Coupling force control – ECE R13

(Proposal from the Danish delegation)

Diagram 1

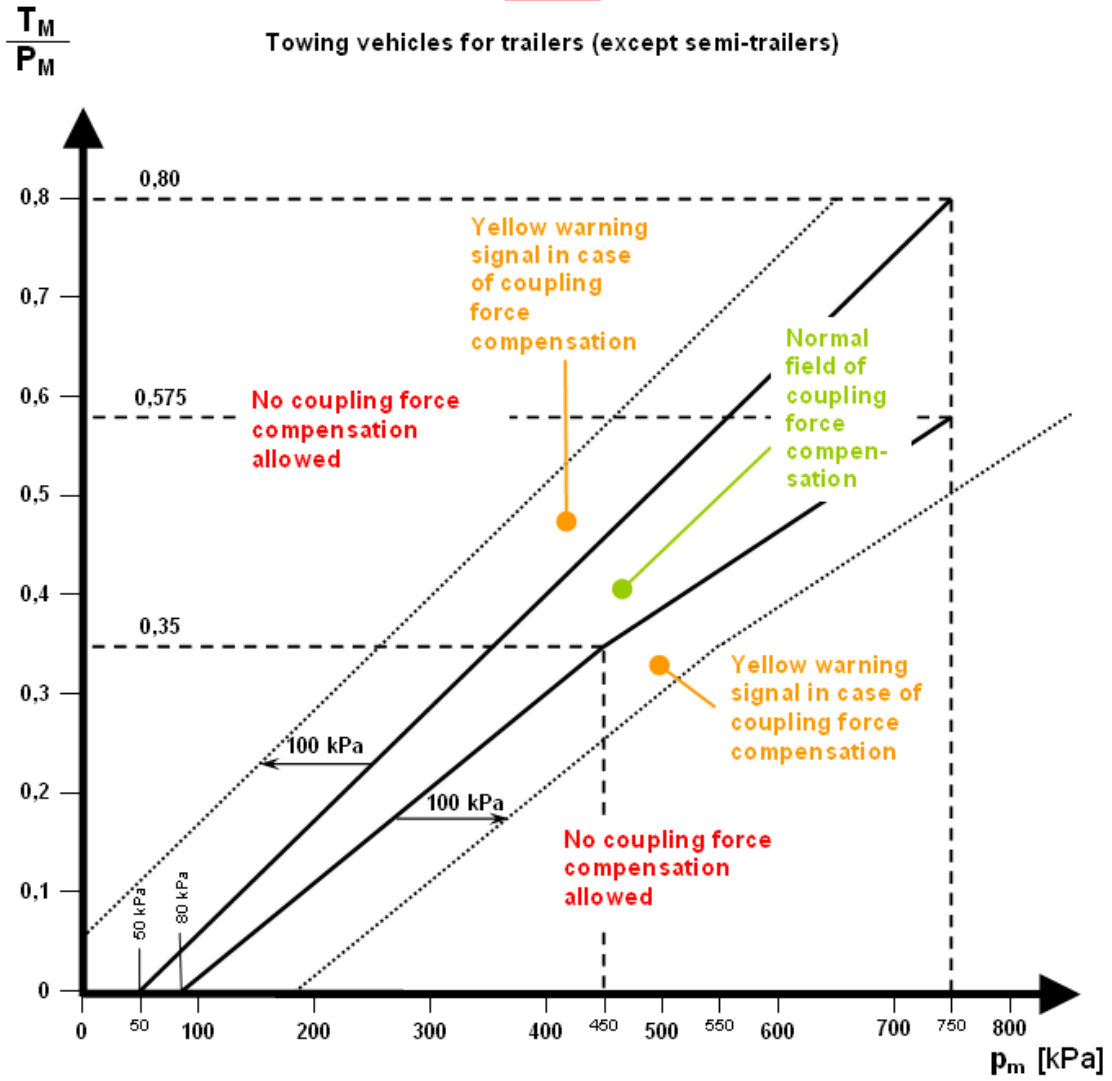
Paragraph 5.2.1.28.5., amend to read:

5.2.1.28.5. The coupling force control system shall tend to minimise the coupling force. Max. allowed compensation by the coupling force control system is 100kPa below the lower limit of the compatibility band and 100kPa above the upper limit of the compatibility band as specified in Annex 10. If this compensation causes the operating point to lie outside the compatibility band as specified in Annex 10 for the motor vehicle the yellow warning signal specified in paragraph 5.2.1.29.1.2 shall be activated. After recoupling no compensation is allowed before the coupling force control system has registered a difference between the braking rates of the vehicles in the combination.
